### AMENDMENTS TO THE DRAWINGS:

#### REMARKS

## Rejection Over TAYLOR

The present invention pertains to a mail sorting device that is illustrated, by way of example, in Figure 4 of the application, which is reproduced below.

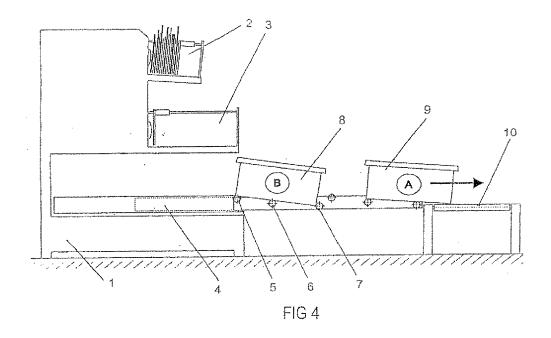
As is described in the specification, the sorting device 1 has two rows, disposed one above the other, of sorting compartments 2,3. For every two sorting compartments 2,3 disposed one above the other, the sorting device 1 has, below said sorting compartments 2,3, a support mechanism 4 on which are located two containers A,B 9,8 one behind the other for accommodating the mail items from the sorting compartments 2,3. The destination addresses to which mail items are statistically sent most frequently are assigned to the lower sorting compartments 3 for ergonomic reasons and the mail items for those destination addresses which do not receive mail items so frequently, i.e., the sorting compartments 2 not needing to be emptied so frequently by the operator, are sorted into the upper sorting compartments 2. If the lower sorting compartment 3 has been

emptied into the container A 9 and the container A 9 is full, the container A 9 is lifted over the roller 7 and pulled onto the roller conveyor track 10.

The above-described aspects of the present invention are reflected in independent claims 8 and 17.

TAYLOR pertains to a baggage receiving device specifically designed for airport passenger luggage handling. The Official Action refers to Figure 1 of TAYLOR, which is reproduced below.

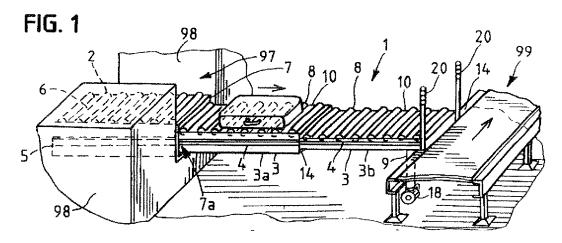
TAYLOR fails to disclose a sorting device with a means or device for sorting mail items into sorting compartments, such as is set forth in independent claims 8 and 17 of the present invention.

TAYLOR additionally fails to disclose rows of sorting compartments disposed above the extendable support mechanism, such as is set forth in independent claims 8 and 17 of the present invention.

TAYLOR thus fails to disclose each and every element of independent claims 1 and 17 of the present invention. TAYLOR accordingly fails to anticipate independent claims 8 and 17 of the present invention. Claims depending upon independent claims 8 or 17 are patentable over TAYLOR for at least the above reasons.
